## 2018/1696/P Representations – Annex

### **Staircase – State of Completion/Poor Standard**

The built staircase.

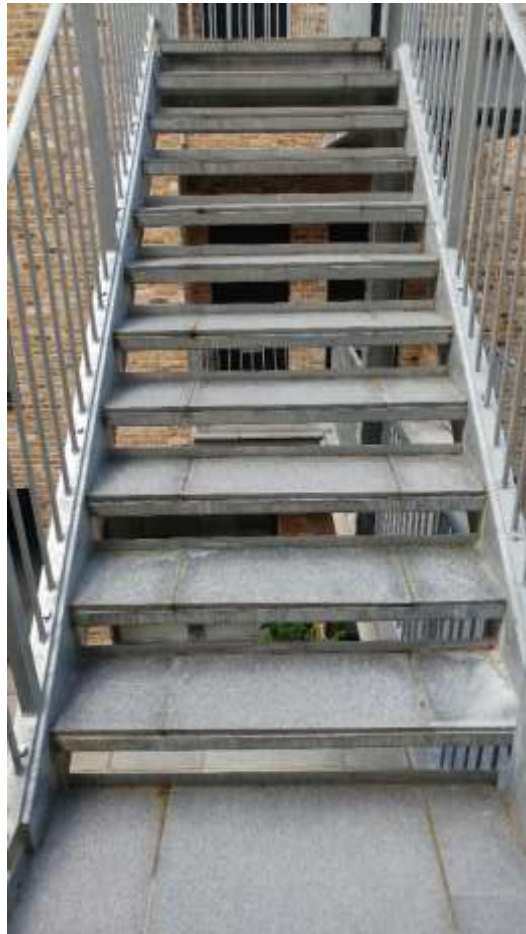
The two flights are 6 and 11 steps instead of 9 and 9. The finish is uncoated galvanised steel. Safety rods not in evidence.

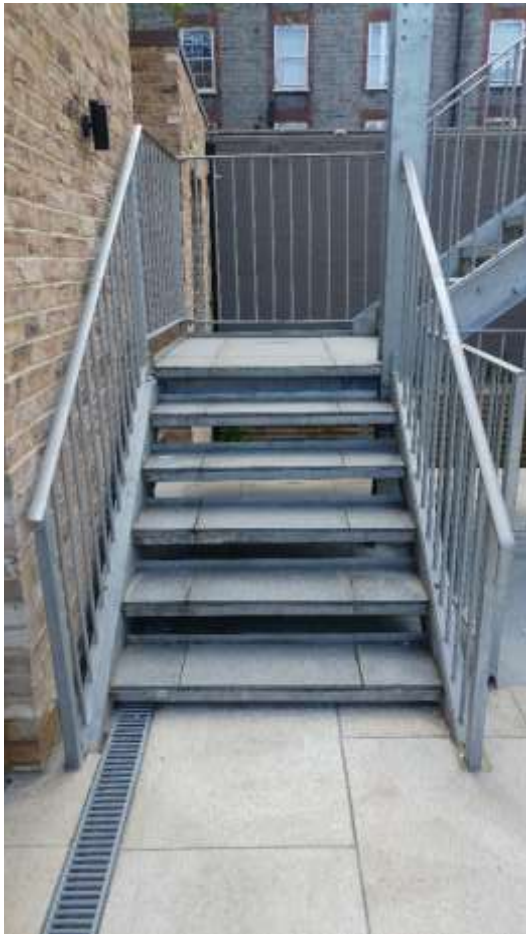
Illustrating the degree to which the staircase, when extended, will dominate the view from the maisonettes.
